**Work Order ID 124543**

Item Name: Crosstube Turning Detail

<b>DART AEROSPACE LTD</b>	<b>Work Order:</b> 124543
<b>Description:</b> Crosstube Assembly	<b>Part Number:</b> D407-667-245
<b>Inspection Dwg:</b> D407-667-245 Rev: F	<b>Page 1 of 2</b>

## D407-667-245 Crosstube wall thickness deviation (B124543)

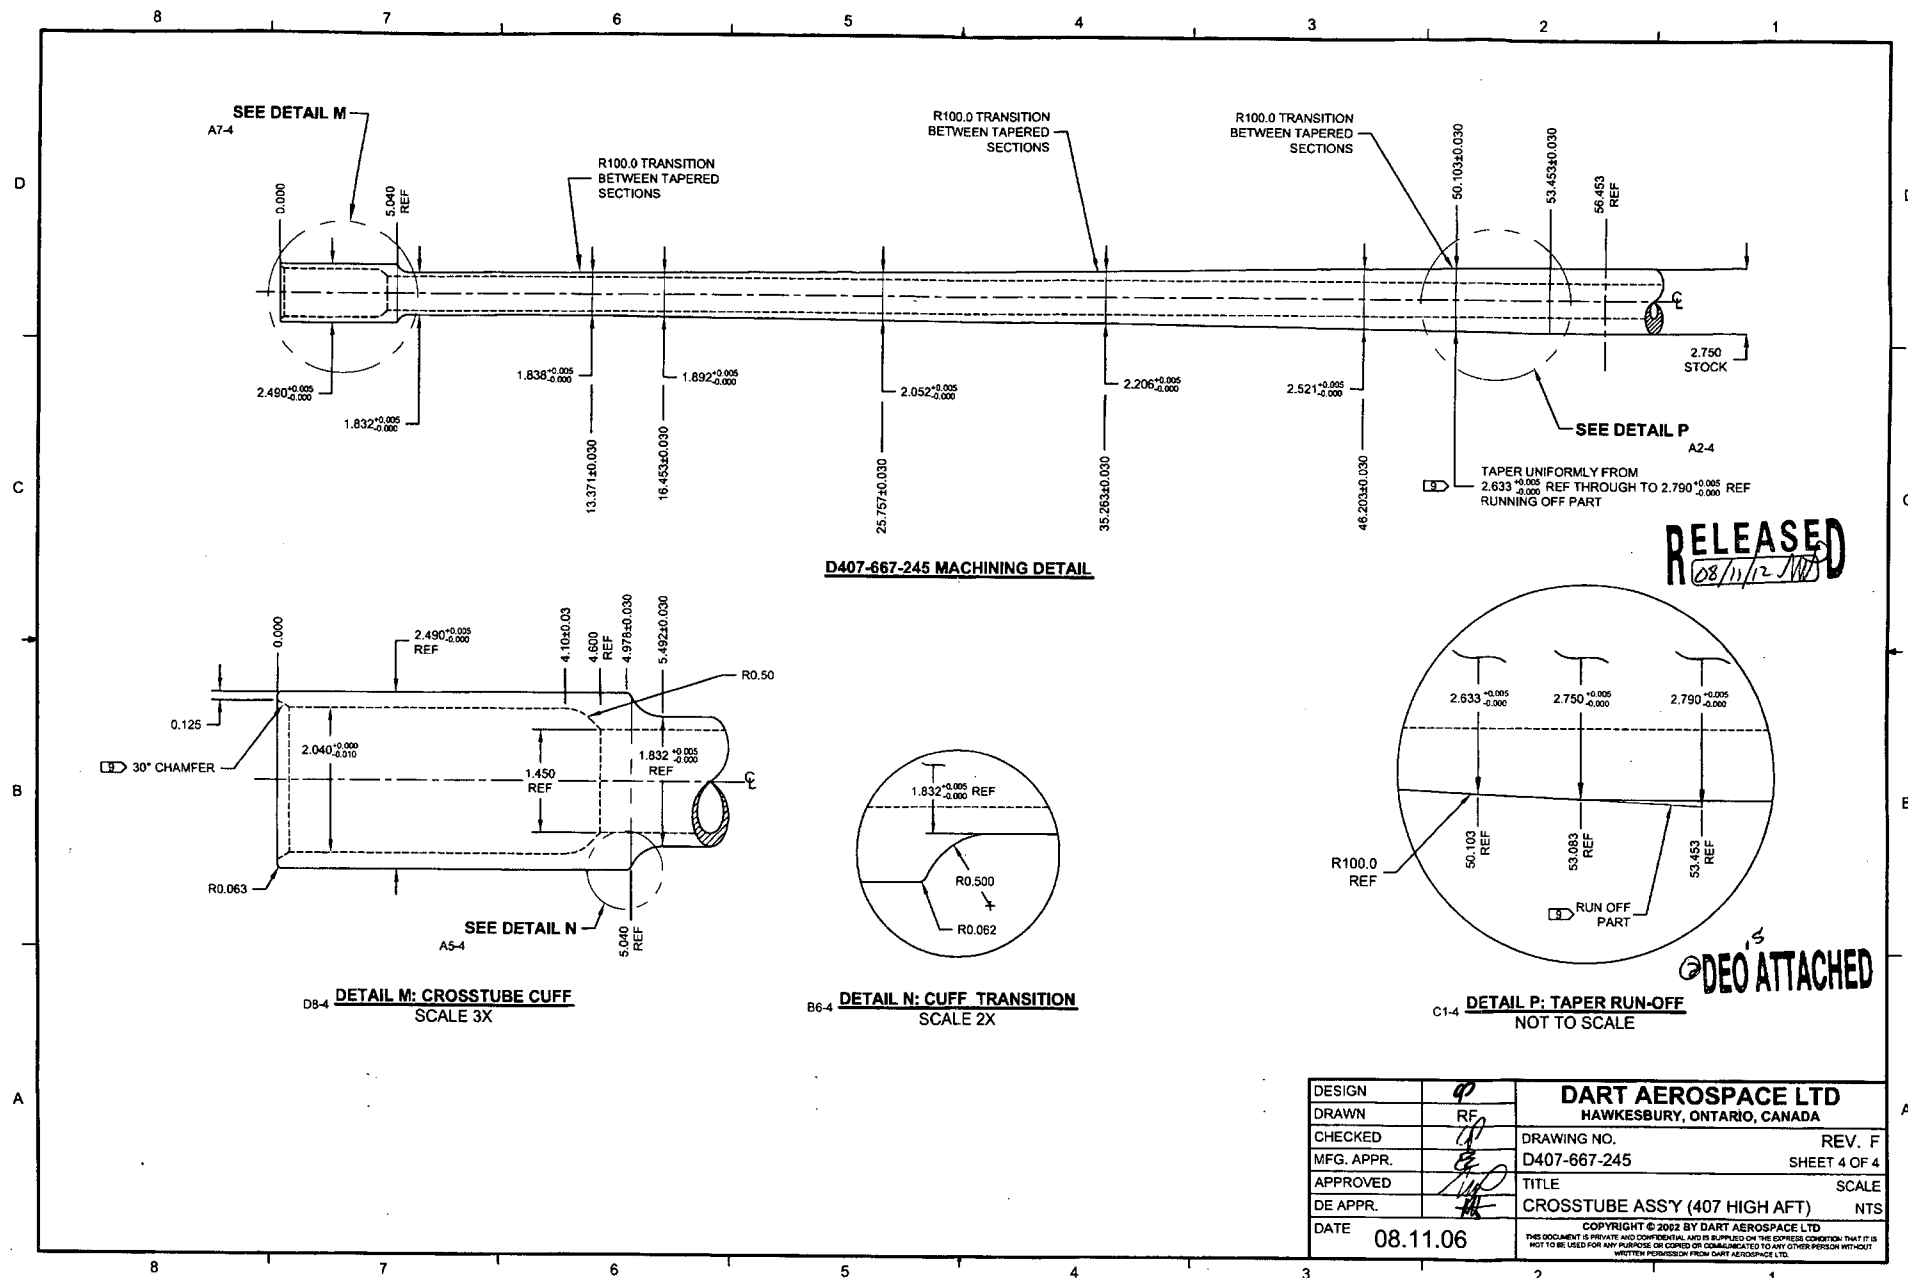
$L_{dev} := 18.67\text{in}$	Location of deviated wall thickness
$X_1 := 16.453\text{in}$	Linear data point 1 (Ref Dart Drawing D407-667-245 Sheet 4)
$X_2 := 25.757\text{in}$	Linear data point 2 (Ref Dart Drawing D407-667-245 Sheet 4)
$Do_1 := 1.892\text{in}$	Diameter at point 1 (Ref Dart Drawing D407-667-245 Sheet 4)
$Do_2 := 2.052\text{in}$	Diameter at point 2 (Ref Dart Drawing D407-667-245 Sheet 4)

$$X_3 := 35.263 \text{ in} \quad \text{Linear data point 1 (Ref Dart Drawing D407-667-245 Sheet 4)}$$

$$X_4 := 46.203 \text{ in} \quad \text{Linear data point 2 (Ref Dart Drawing D407-667-245 Sheet 4)}$$

$$D_{0,3} := 2.206 \text{ in} \quad \text{Diameter at point 1 (Ref Dart Drawing D407-667-245 Sheet 4)}$$

$$D_{0,4} := 2.521 \text{ in} \quad \text{Diameter at point 2 (Ref Dart Drawing D407-667-245 Sheet 4)}$$

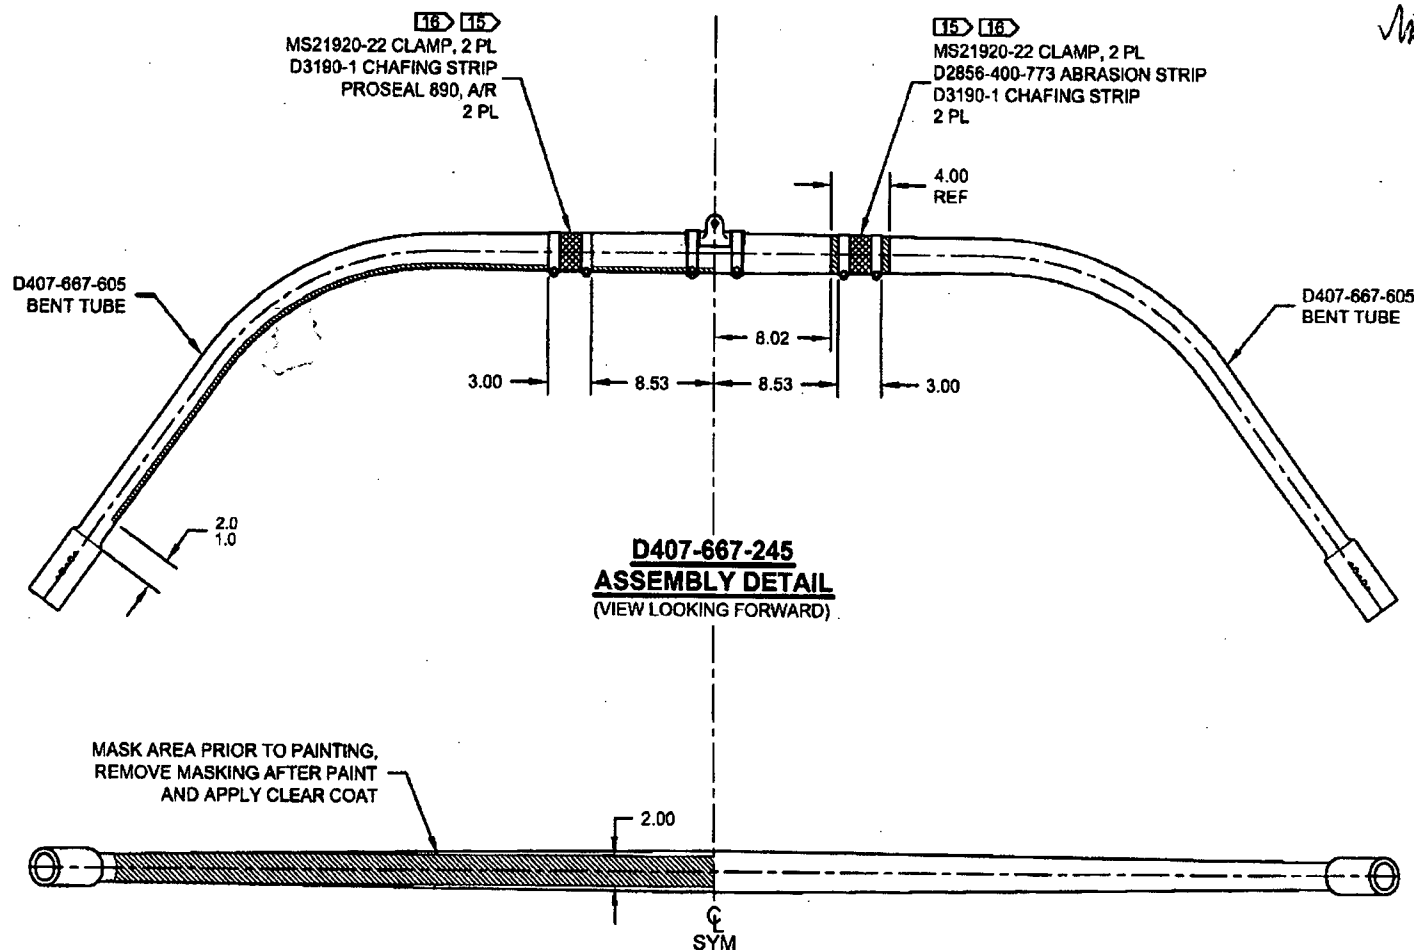
REMOVED ABRASION STRIP IN FAVOR OF A THIN LAYER OF PROSEAL 890.

- 2) FINISH: CHEMICAL CONVERSION COAT PER DART QSI 005 4.1  
PRIME INSIDE AND OUTSIDE PER DART QSI 005 4.2  
MASK UNDERSIDE OF CROSSTUBE AS SHOWN (HATCHED AREA) AND  
PAINT OUTSIDE PER DART QSI 005 4.2  
REMOVE MASKING AND APPLY CLEAR COAT
- 15) APPLY A THIN COAT OF PROSEAL 890 ON INSIDE CONCAVE SURFACE OF D3190-1  
CHAFING SHIELDS AND LET CURE PER MANUFACTURER'S INSTRUCTIONS. INSTALL  
PROSEALED D3190-1 CHAFING SHIELDS ONTO CROSSTUBE BY APPLYING A THIN COAT  
OF PROSEAL 890 ONTO CROSSTUBE. BE SURE TO ELIMINATE ANY AIR GAPS.
